UNITED STATES PATENT AND TRADEMARK OFFICE

APPLICATION NO.	FILING DATE	FIRST NAMED INVENTOR	ATTORNEY DOCKET NO.	CONFIRMATION NO.
10/806,870	03/23/2004	Paul B. Rivers	04-BS001 (BS030749)	2701
38515	7590	07/12/2006	EXAMINER	
BAMBI FAIVRE WALTERS PO BOX 5743 WILLIAMSBURG, VA 23188			CAJILIG, CHRISTINE T	
			ART UNIT	PAPER NUMBER
			3637

Office Action Summary

DETAILED ACTION

Edwards (U.S. Patent No. 6,158,180).

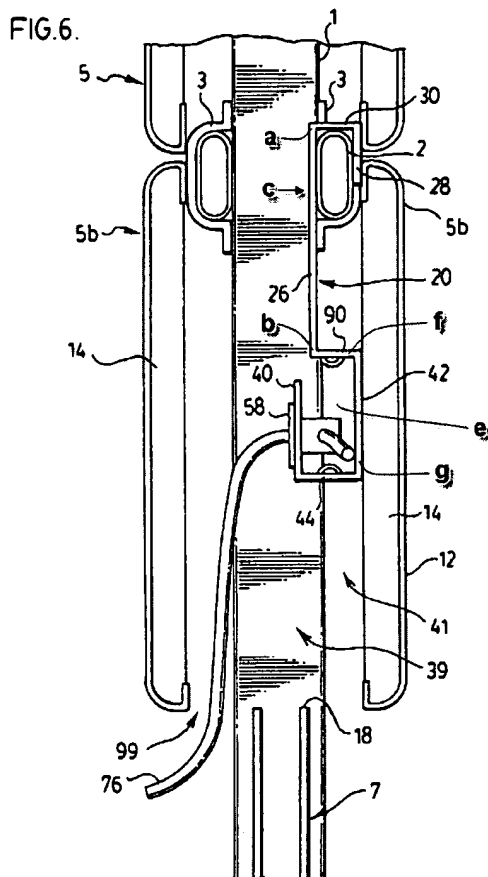
31. Regarding claim 1, Edwards in Figure 6 discloses a wire channel comprising:

a. an upwardly extending arm (26) having a top portion (a), a bottom portion (b), an inner surface (c), and an outer surface (20), the outer surface (20) of the top portion (a) having a projection (30, 28) to engage and to secure the wire channel device between an upper siding panel and a lower siding panel. The phrase "to engage and to secure the wire channel device between an upper siding panel and a lower siding panel" is regarded to as functional language and while features of an apparatus may be recited either structurally or functionally, claims directed to an apparatus must be distinguished from the prior art in terms

b. a transverse leg (90) extending outwardly from the outer surface of the bottom portion of the arm towards a downwardly extending leg (42) of a wire channel.

c. the wire channel having the downwardly extending leg (42), a channel portion (44), and a rear upwardly extending leg (40), wherein the downwardly extending leg (42) is longer than the rear upwardly extending leg (40) and wherein an interior (3) of the channel portion (44) defines a channel to retain a wire.

36. Regarding claim 15, Edwards in Figure 6 discloses a wire channel comprising:

a. a transverse leg (90) extending outwardly towards a downwardly extending leg (42) of a wire channel, wherein the transverse leg is capable of

extending beneath a rearwardly facing hook portion of an upper siding panel. As noted in paragraph 26 of this office action, for purpose of examination the claims are considered as directed to the wire channel device; therefore, the phrase "wherein the transverse leg extends beneath a rearwardly-facing hook portion of an upper siding panel" shall be considered as functional language.

b. the wire channel having the downwardly extending leg (42), a channel portion (44), and a rear upwardly extending leg (40), wherein the downwardly extending leg (42) is longer than the rear upwardly extending leg (40) and wherein the channel portion (44) defines a channel (e) to retain a wire.

37. Regarding claim 16, Edwards in Figure 6 discloses a wire channel comprising:

a. at least one upwardly extending arm (26) having a top portion (a), a bottom portion (b), an inner surface (c), and an outer surface (20), the outer surface (20) of the top portion (a) having a projection (30, 28) capable of engaging and securing the wire channel device between the lip portion of the upper siding panel and a complimentary hooked portion of a lower siding panel. The phrase "to engage and to secure the wire channel device between the lip portion of the upper siding panel and a complimentary hooked portion of a lower siding panel" is regarded to as functional language and while features of an apparatus may be recited either structurally or functionally, claims directed to an apparatus must be distinguished from the prior art in terms of structure rather than function. See MPEP §2114. Furthermore, the projection (30, 28) could perform the function stated above.

- b. a portion of the outer surface (20) of the bottom portion (b) connected with the transverse leg (90).

FIG. 29

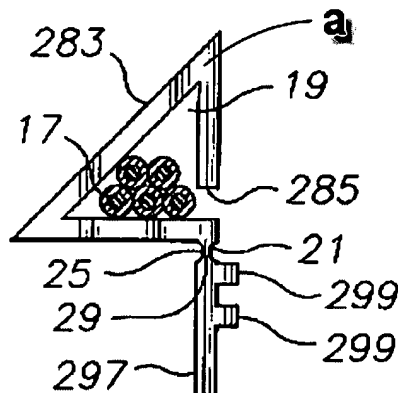
40. Regarding claim 4, Edwards discloses a wire channel as discussed above but does not disclose a channel portion comprising a substantially "V"-shaped channel. However, Zimmerman in Figure 29 discloses a flanged conduit having a channel portion (a) comprising a substantially "V"-shaped channel (19). Therefore, it would have been obvious to a person having ordinary skill in the arts at the time of the applicant's invention to modify the wire channel of Edwards to include a channel portion comprising a substantially "V"-shaped channel as taught by Zimmerman to provide a channel with a variety of configurations (Col 2, Ln 19-21).

41. Regarding claim 10, Edwards discloses a wire channel as discussed above but does not disclose the downwardly extending leg extending downward at an angle of at least thirty degrees toward the arm. However, Zimmerman in Figure 29 discloses a flanged conduit having the downwardly extending leg (283) extending downward at an angle of at least thirty degrees toward the arm (297). Therefore, it would have been obvious to a person having ordinary skill in the arts at the time of the applicant's invention to modify the wire channel of Edwards to include the downwardly extending leg extending downward at an angle of at least thirty degrees toward the arm to provide a channel with a variety of configurations (Col 2, Ln 19-21).

Brooks (U.S. Patent No. 5,823,655)

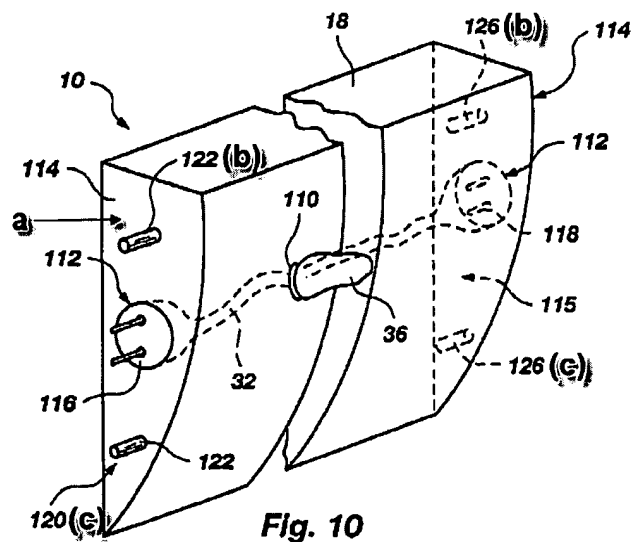
43. Regarding claims 5 and 17, Edwards discloses a wire channel as discussed above and also including transverse leg (90) comprising a first lateral side (f) and a second lateral side (opposite side of (f)) but does not disclose the first lateral side having a female repository and the second lateral side having a male projection, wherein the male projection of a first wire channel device mates with the female repository of a second wire channel device such that the first wire channel snap fits into alignment and secures with the second wire channel. However, Brooks in Figure 10 discloses channeled molding having a transverse leg (114) further comprising a first lateral side (115) and a second lateral side (a), the first lateral side having a female repository (126 (b)) and the second lateral side having a male projection (122 (b)),

wherein the male projection of a first wire channel device mates with the female repository of a second wire channel device such that the first wire channel snap fits into alignment and secures with the second wire channel (Col 7, Ln 54-56). Therefore, it would have been obvious to a person having ordinary skill in the arts at the time of the applicant's invention to modify the wire channel of Edwards to include the first lateral side having a female repository and the second lateral side having a male projection, wherein the male projection of a first wire channel device mates with the female repository of a second wire channel device such that the first wire channel snap fits into alignment and secures with the second wire channel as taught by Brooks to provide a means for extending the length of the channel.

44. Regarding claims 6 and 18, Edwards discloses a wire channel as discussed above and also including the downwardly extending leg (42) further comprising a first lateral side (g) and a second lateral side (opposite side of (g)) but does not disclose the first lateral side having a female repository and the second lateral side having a male projection, wherein the male projection of a first wire channel device mates with the female repository of a second wire channel device to align and secure the first wire channel device with the second wire channel device. However, Brooks in Figure 10 discloses channeled molding having a first lateral side (115) and a second lateral side (a), the first lateral side having a female repository (126 (c)) and the second lateral side having a male projection (122 (c)), wherein the male projection of a first wire channel device mates with the female repository of a second wire channel device such that the first wire channel snap fits into alignment and secures with the second wire channel (Col
